CLARIFICATIONS FOR THE SUPPLY AND INSTALLATION OF KASOA BSP - DESIGN-BUILD

BID REFERENCE: 5140400-05/IFB/CB/06/19

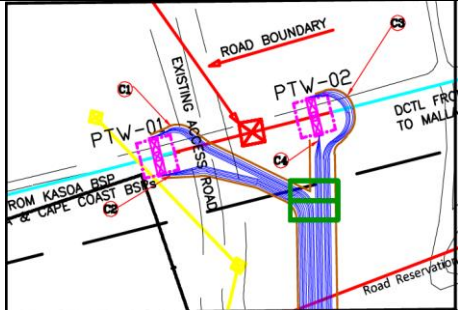
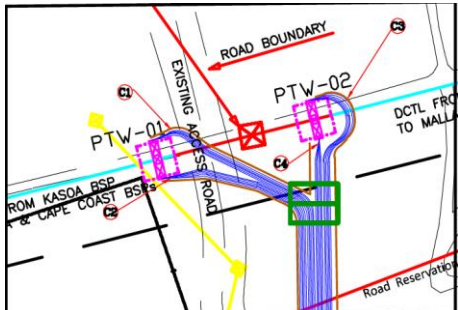
56	VOLUME CHAPTER 7: Page 180	As per the mentioned Clause, the physical arrangement and the schematic of the PLC coupling at the Terminal Towers is shown in the drawing number PMC-5091019-BSP-KAS-T-105. Please provide us the drawing as the same is not found in tender documents.	The schematic of the PLC coupling at the Terminal Towers is shown in the drawing number PMC-5091019-BSP-KAS-T-101, which is already attached.
57	VOLUME IIB Clause 15.6.5 Design	Please provide us the TYPICAL 34.5kV FEEDER STRUCTURE ARRANGEMENT drawing as mentioned in the specification.	The Typical 34.5kV Feeder Structure arrangement drawing as mentioned in the specification is shown on Drawing number PMC-5091019-BSP-KAS-C-110, which can be downloaded on the following link: http://bit.do/KasoaBSP

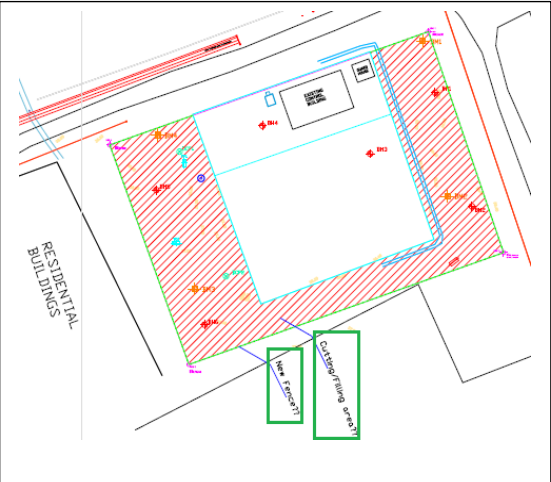
89	Right of way for 161kV New terminal & Tension tower	<p>We observed that the existing 33kV ECG line tower is very near to the proposed tower PTW-01. Please confirm the required ROW will be obtained by Client and no modification of existing 33kV ECG line if any won't be in bidder's scope of work.</p>	<p>The Relocation of the existing 33kV ECG line tower shall not be required.</p>
90	VOLUME IIB CL:1.10.1	<p>"Protection panels at remote ends of the line sections should be retrofitted with line differential protection relays identical to those to be provided at the Kasoa BSP." – We propose only supply of remote end relays; retrofitting or rewiring or supply of new panels is out of our scope. Kindly confirm</p>	<p>The supply, retrofitting and rewiring and commissioning or supply of new panels of remote end relays shall be IN the scope of the Contactor.</p>
91	VOLUME IIB CL:1.6 PAGE 10	<p>"Insulation Co-ordination Studies for the full development" - For the purpose of bidding we</p>	<p>This is a design, manufacture, supply, installation and commissioning contract. No variation shall be considered.</p>

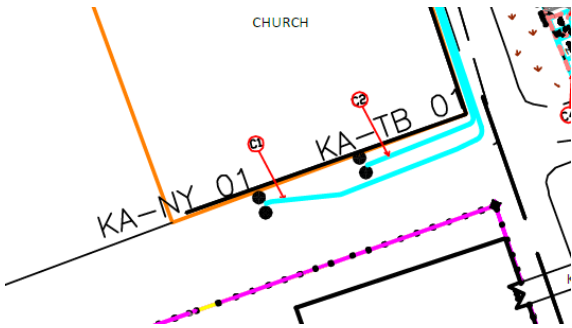
135		The specification seems to be required the Surge arrester in the GIS and following the SLD seem to be required in the bus bar. Please confirm that the surge arrester of the GIS will be located in the bus	The Surge arresters in the GIS shall be in the GIS on locations indicated on the SLD

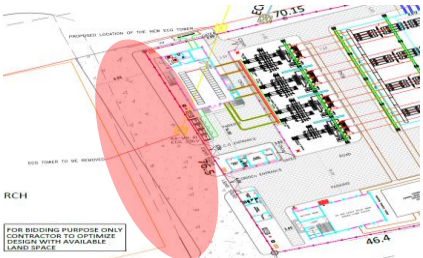
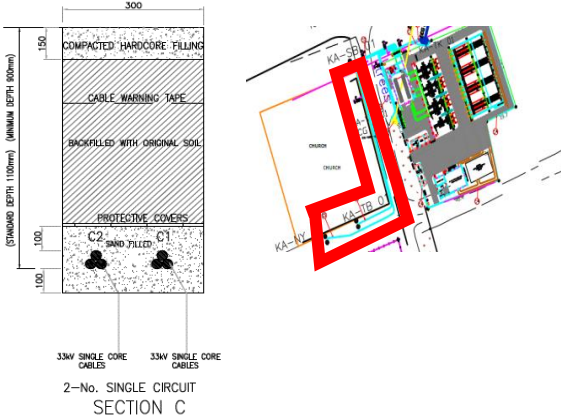
137	Volume-II B. 7.0 Telecommunication, SAS SCADA and IP CCTV	<p>It is specified in the section the need of 12 CVT but this is not included in the Schedule of prices.</p> <p>"Twelve (12) CVTs will be required for the four (4) Lines from Kasoa but only six (6), which will be used for PLC Coupling, will be installed at the Terminal Towers. The remaining CVTs without PLC Coupling will be installed at the Switchyard."</p> <p>Please confirm that this 12CVT is not needed or they are the Voltage transformer located in the Line bay GIS</p>	<p>CVT's at the terminal towers are not required. However, Line Traps and all associated equipment like coupling capacitors shall be required at the terminal towers.</p> <p>Instead, 161 kV VTs shall be placed integral to the GIS</p>
